SUBJECT: NuScale Power, LLC Response to NRC Request for Additional Information No. 380 (eRAI No. 9394) on the NuScale Design Certification Application

Response to Request for Additional Information Docket No. 52-048

eRAI No.: 9394

Figure 5-1. Human engineering discrepancy resolution process

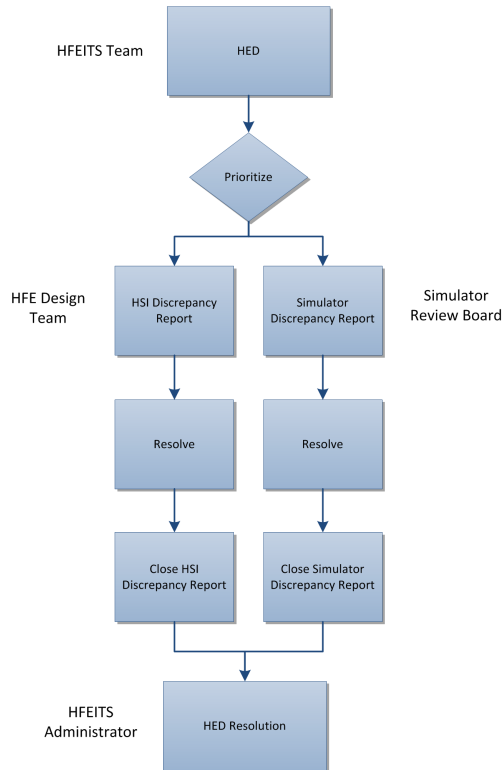
In Section 5.1 of the V&V IP the applicant explains that after an HED has been prioritized, it is routed to the HFE design team, simulator review board, or both as appropriate for resolution. Please clarify how (i.e. the method by which) design solutions are evaluated to ensure HEDs are resolved and no new HEDs are introduced.

RP-0914-8543, Human Factors Verification and Validation Implementation Plan (V&V IP), Section 5.3, Design Solution Testing, has been added to address actions associated with how design solutions are dispositioned for human engineering discrepancies (HEDs). In summary, design solutions are verified to be acceptable using the same V&V method that originally

A test, as prescribed in Section 5.3 of the V&V IP, is performed to evaluate the design solution. Performance data is collected and compared to objective acceptance criteria. ISV monitoring techniques are utilized during the test to ensure no new HEDs are introduced as a result of the original issue resolution. If a new HED is identified, then either a different resolution is identified and tested or the same process is utilized to resolve the new HED.

The HED is then routed to the appropriate group for resolution. HEDs related to the HSI are sent to the HFE design team, and HEDs related to simulator modeling are sent to the simulator review board. It is possible for HEDs to be routed to both groups.

The HED is then resolved, and the discrepancy entry closed. The HED resolution is reviewed for final closure in the HFEITS database by an HFE Review committee. The HED resolution process is depicted in Figure 5-1.
